ELEMENTARY WIRING DIAGRAM
MOTOR OPERATED VALVE

COMP. CODE NO. 15-94-3620
B-SYS80-414-353

REVIEW AND COMMENT

WASHINGTON PUBLIC POWER SUPPLY SYSTEM
 WPPSS NUCLEAR PROJECT NO. 3

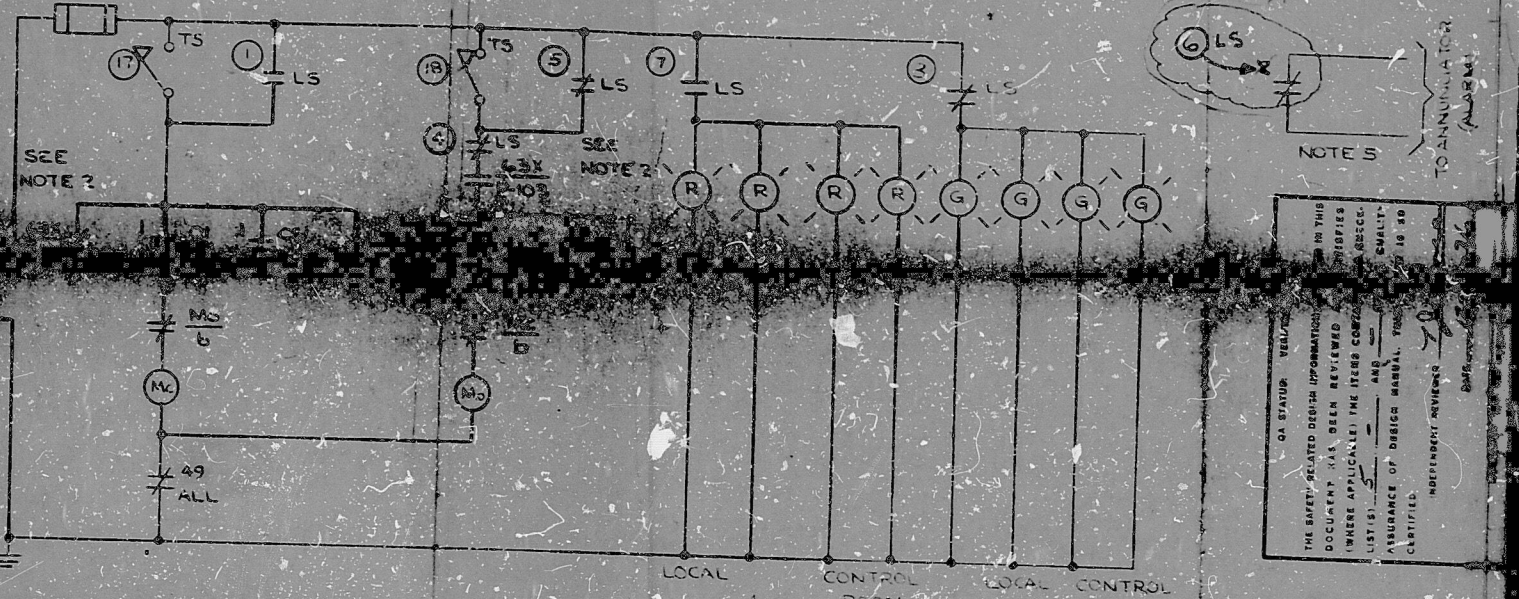
THIS DWG DOES NOT AGREE WITH LOGIC DIAG B-SYS 80-414-353 SHT. 4
